APPLICATION NO.	FILING DATE	FIRST NAMED INVENTOR	ATTORNEY DOCKET NO.	CONFIRMATION NO.
10/585,450	07/07/2006	Shoji Akatsuka	Q89687	2865
23373 7590 01/28/2009 SUGHRUE MION, PLLC 2100 PENNSYLVANIA AVENUE, N.W. SUITE 800 WASHINGTON, DC 20037			EXAMINER	
			GISSEL, GUNNAR J	
			ART UNIT	PAPER NUMBER
			2856	
			MAIL DATE	DELIVERY MODE
			01/28/2009	PAPER

Application No.	Applicant(s)				
Office Action Comments	10/585,450	AKATSUKA ET AL.				
Office Action Summary	Examiner	Art Unit				
	Gunnar J. Gissel	2856				
The MAILING DATE of this communication app Period for Reply	ears on the cover sheet with the c	orrespondence address				
A SHORTENED STATUTORY PERIOD FOR REPLY IS SET TO EXPIRE 3 MONTH(S) OR THIRTY (30) DAYS, WHICHEVER IS LONGER, FROM THE MAILING DATE OF THIS COMMUNICATION. - Extensions of time may be available under the provisions of 37 CFR 1.136(a). In no event, however, may a reply be timely filed after SIX (6) MONTHS from the mailing date of this communication. - If NO period for reply is specified above, the maximum statutory period will apply and will expire SIX (6) MONTHS from the mailing date of this communication. - Failure to reply within the set or extended period for r

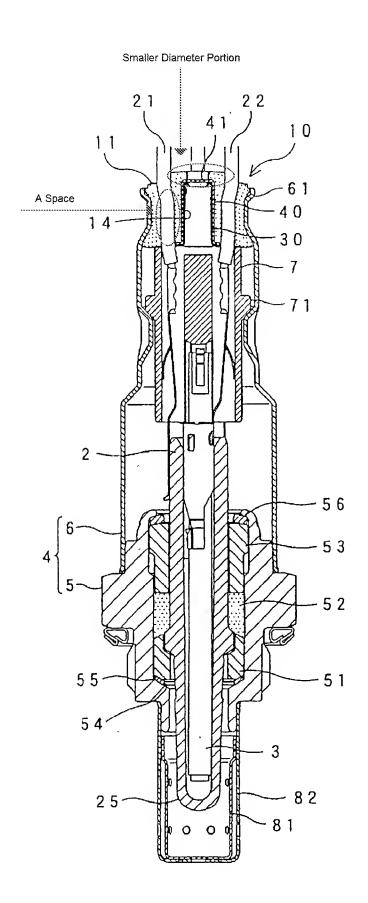
4. Applicant's arguments filed 11/05/2008 have been fully considered but they are not persuasive. Regarding Claims 1, 3, 4 and 8, 9, Applicant argues that the elastic seal member is disposed such that a smaller diameter portion protrudes and such that

the elastic seal member is disposed astride the rear end of the outer tubular member, while at the same time a space is formed between the smaller diameter portion of the elastic seal member and the rear end of the tubular metallic member. Fujita depicts an arrangement that can be so described, shown below.
